1. Date of Application: 12/9/21
2. Date of Plan or Revision: 11/30/21
3. Application for: Butler Ave Mixed Use
4. Name of Subdivision or Land Development: Butler Ave Mixed Use
5. Location: 409 W. Butler Ave
6. Tax Map Parcel #: 26-005-023 Total Acreage: Gross 7.3 Net 6.6
7. Net Buildable Site Area (from Section 2401): 6.6 acres
8. Zoning Requirements:

PRELIMINARY AND FINAL LAND DEVELOPMENT PLANS

RE: Fire Marshal review Butler Avenue Property T.P. # 26005-023

BUTLER AVENUE PROPERTY
 TMP # 26-005-023
 NEW BRITAIN TOWNSHIP, BUCKS COUNTY, PA
RECORD SITE PLAN

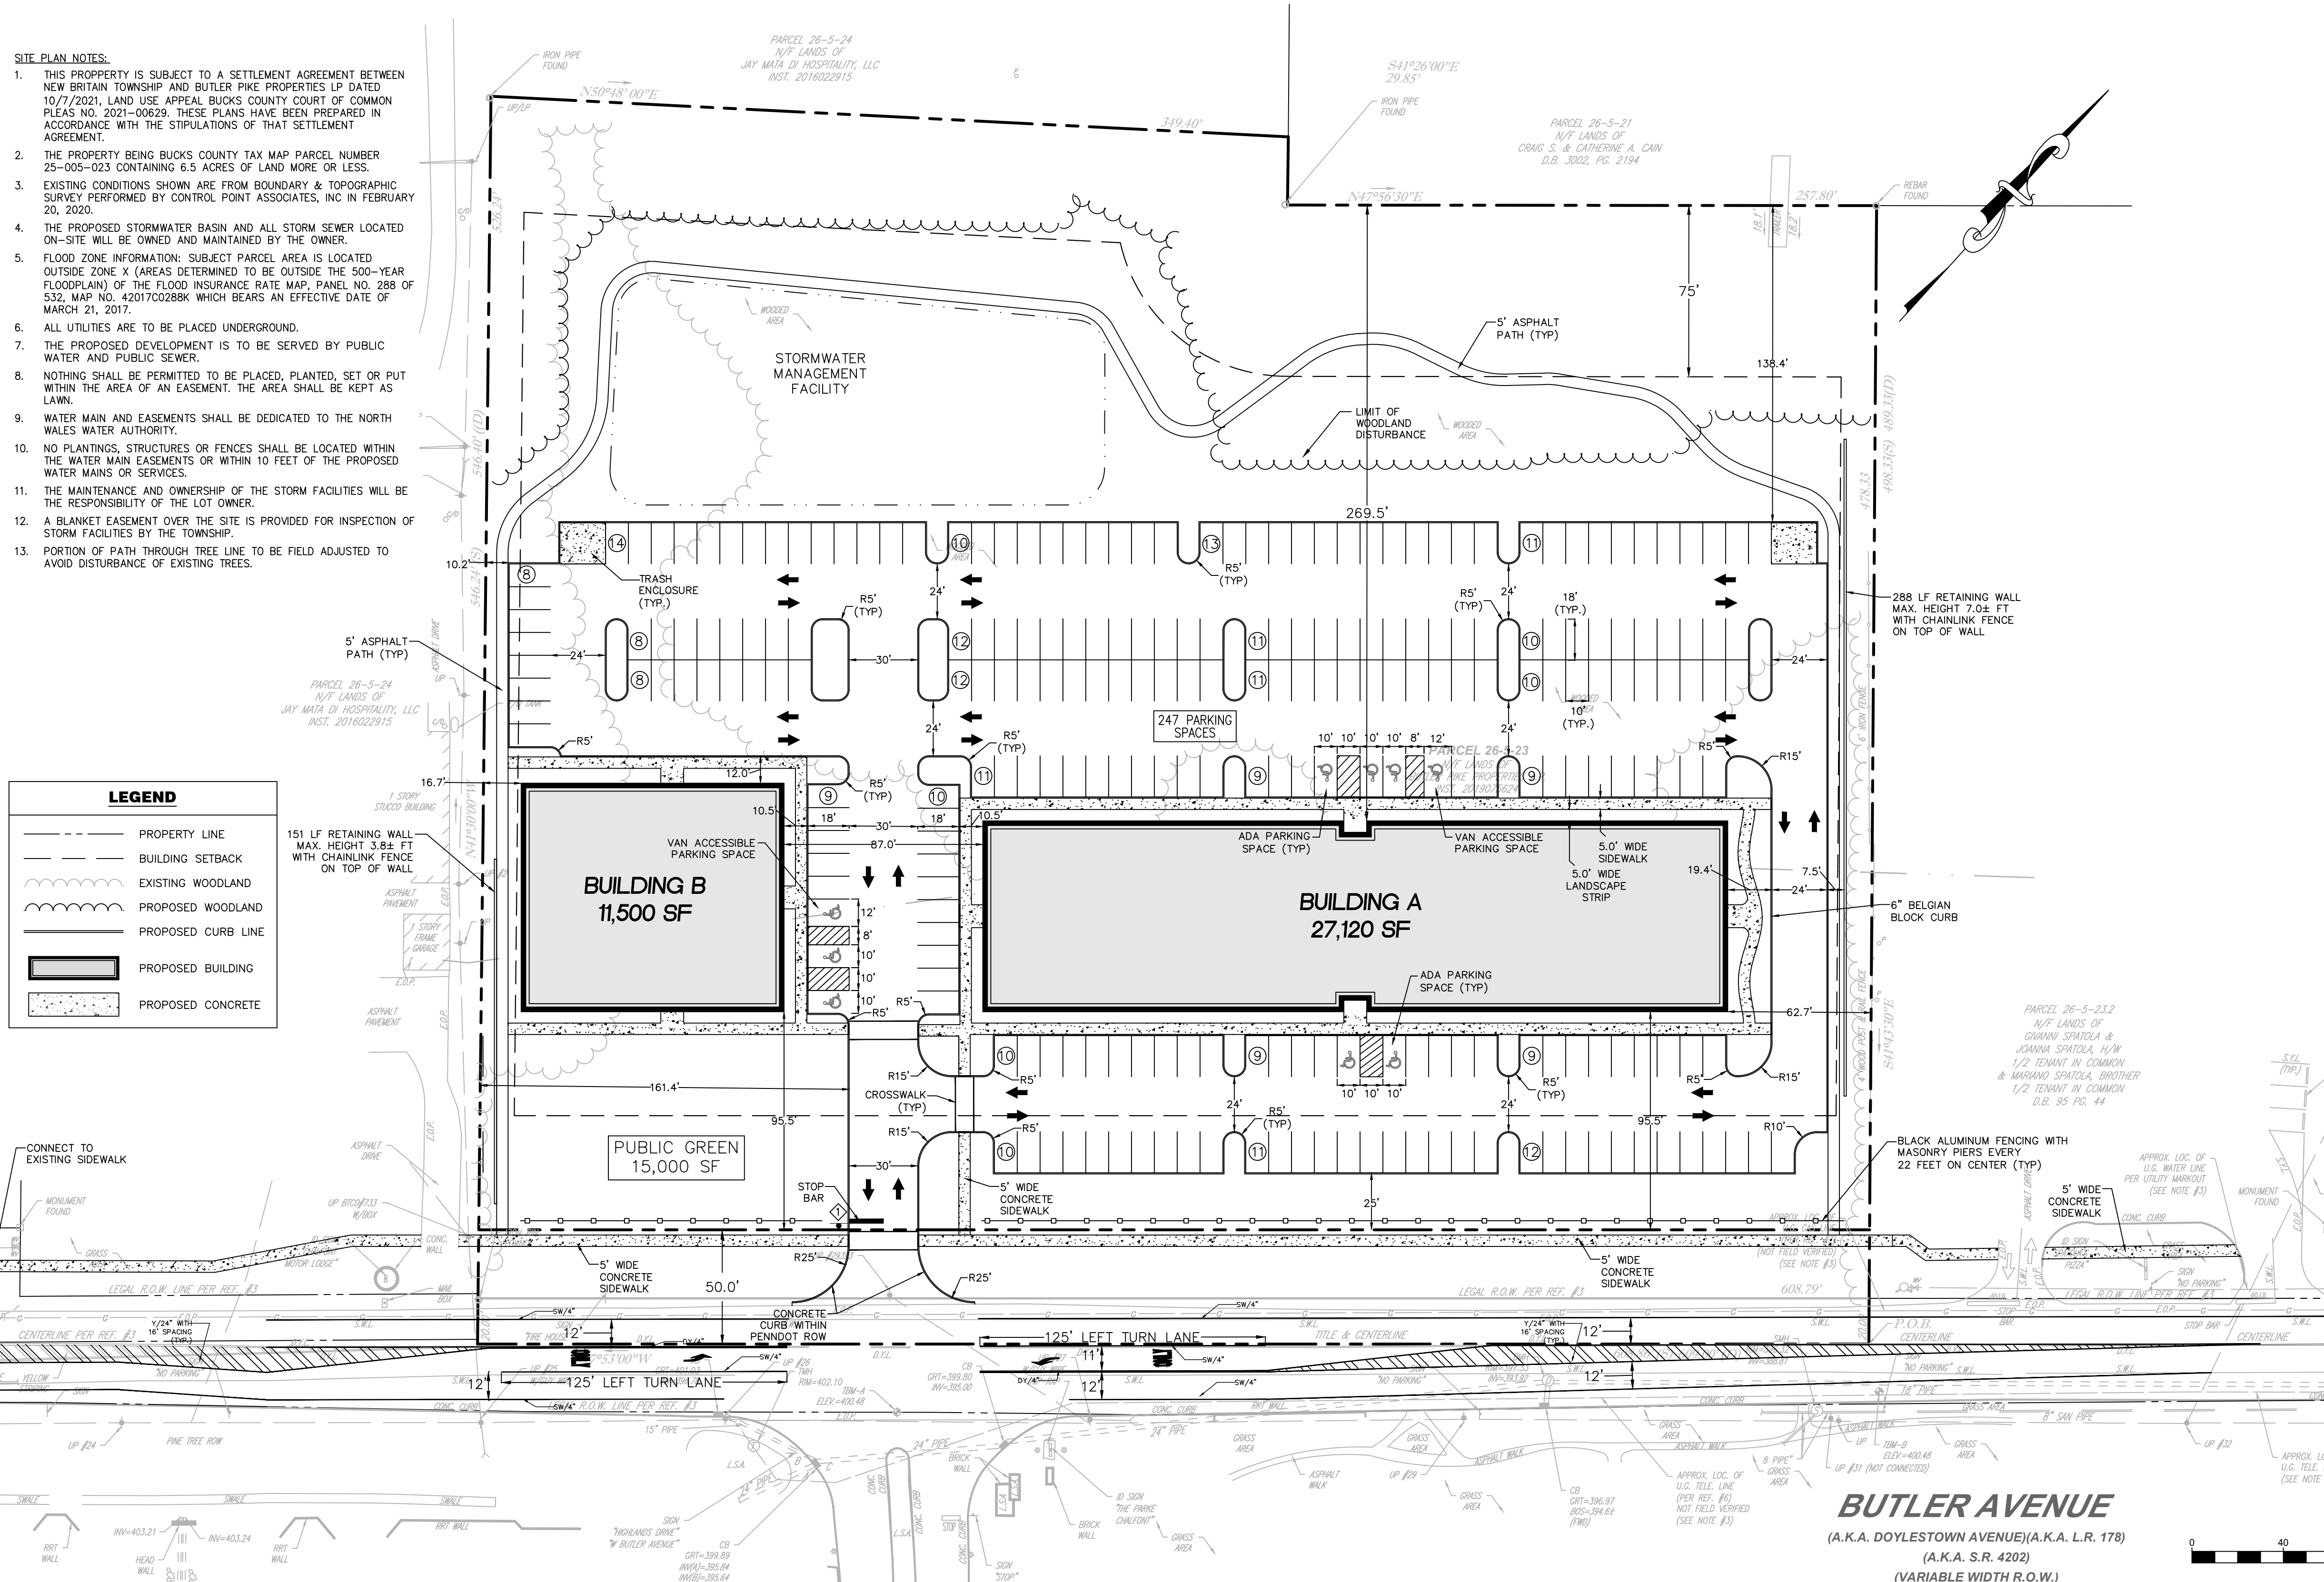
1. §27-201 – The ratio base site area is the area definition used to calculate the impervious and building areas for the site. It shall be clarified that the coverage calculations on Sheet 4 of 21 utilize the Ratio Base Site Area.

2. §27-1202.a – No use in the C-1 Commercial District shall exceed 35 feet in height, however, apartment buildings, Use B7, are permitted to be 40 feet. The proposed building heights and maximum permitted height shall be noted on the Record Plan, Sheet 4.

3. §27-1202.b – The front, side and rear yard setback lines shall be dimensioned and labeled on the Record Plan, Sheet 4. We note that apartment buildings have separate setback requirements for the B7 Use.

BUTLER AVENUE PROPERTY
TWP # 26-005-023
NEW BRITAIN TOWNSHIP, BUCKS COUNTY, PA

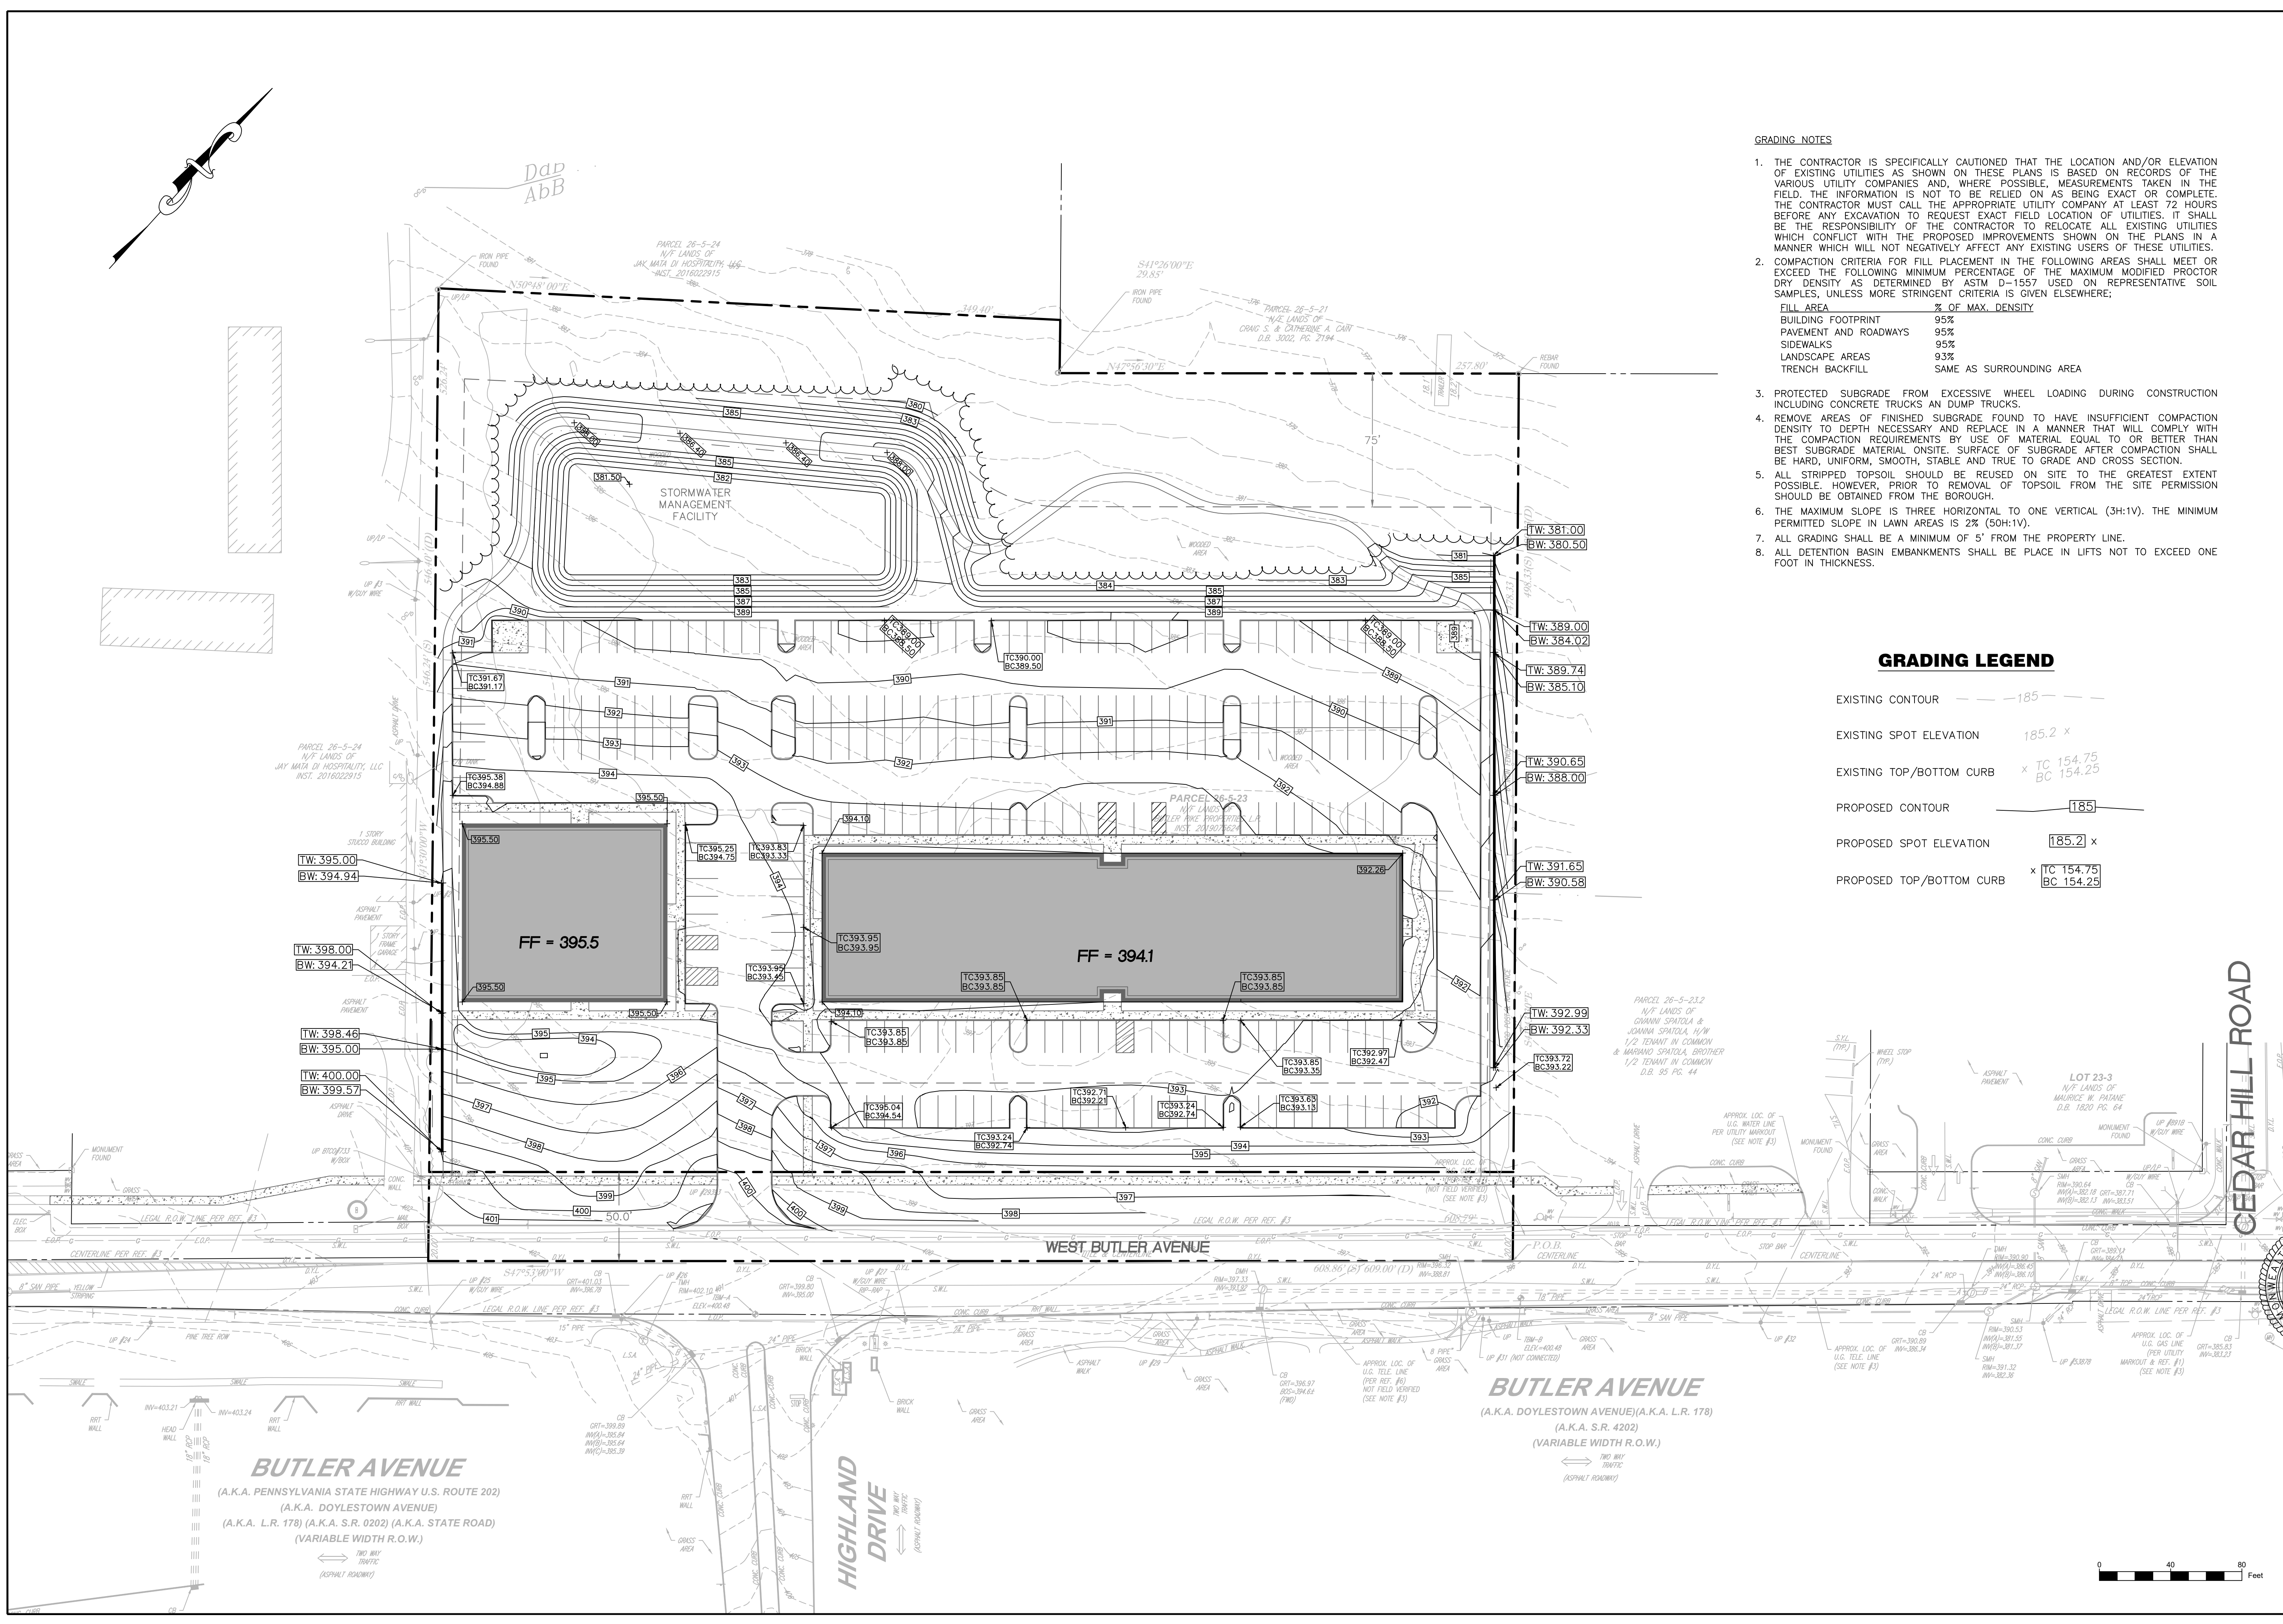
18. §22-706.3.B – All curbs and sidewalks shall provide access in accordance with accessibility guidelines. The PennDOT Curb Ramp detail provided on Sheet 5 does not appear to be applicable. The Detailed Grading Plan of the crosswalks and accessible ramps shall include additional spot elevations for the sidewalk showing a maximum 2% slope at all landing and turning areas.

21. §22-707.C – The Asphalt Trail detail on Sheet 5 shall be revised to specify 2 ½ inches of 9.5mm Superpave wearing course.
22. §22-708.6.B – The grade of parking areas shall be a maximum of 5% and a minimum of 1%. The parking area behind Building B and a portion of the center aisle behind Building A have slopes which exceed 5%. The parking lot grading shall be revised as necessary to meet this requirement.

43. §22-713.5.B.(2) – This section requires, at a minimum, a 6-foot wooden shadow-box fence with a staggered row of evergreen trees be provided at 10-foot spacings to screen from trash areas. We note that the Trash Enclosure Detail provided on Sheet 5 of 21 Site Construction Details indicates that a board on board fence OR a black vinyl chain link fence with privacy slats will be utilized. The proposed screening shall be provide in accordance with the Ordinance and clarified and detailed on Sheet 5 of 21, Site Construction Details.
